# Service Bulletin

Bulletin No.: P11014

**Subject:** Information on Roll-up Soft Tonneau Cover Side Rail Clamp Locator Sticker Out of Position

**Models:** 2014 Chevrolet Silverado 1500  
2014 GMC Sierra 1500

3512695

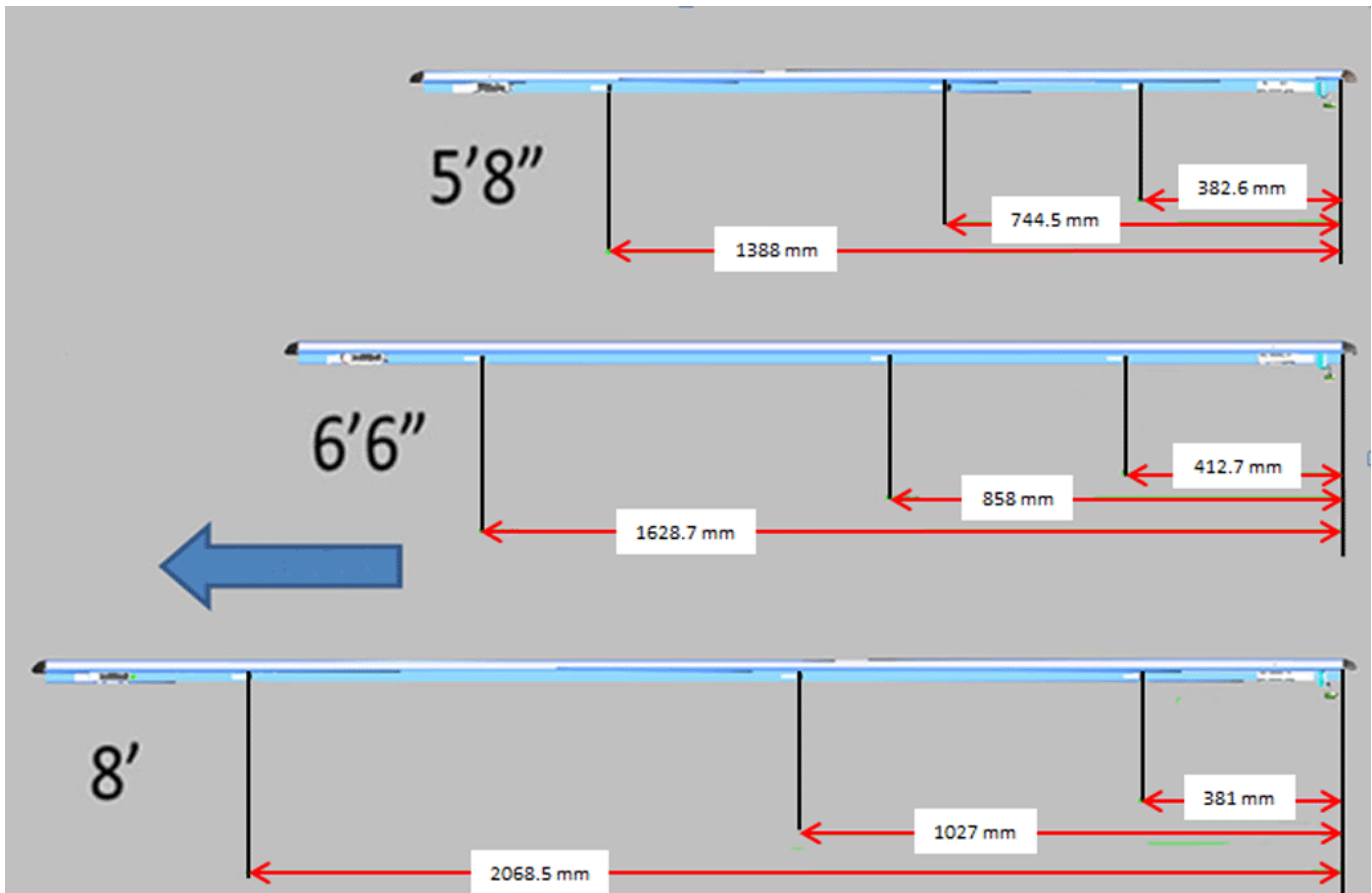
As shown circled in the graphic above, the tonneau side rails have clamp locator stickers intended to show the proper position for the tonneau clamps.

The cause of this condition may be the tonneau clamp locator stickers are positioned too far rearward within a particular segment of the early part builds. The graphic above shows an example in which the sticker is approximately 241 mm (9.5 in) too far rearward.
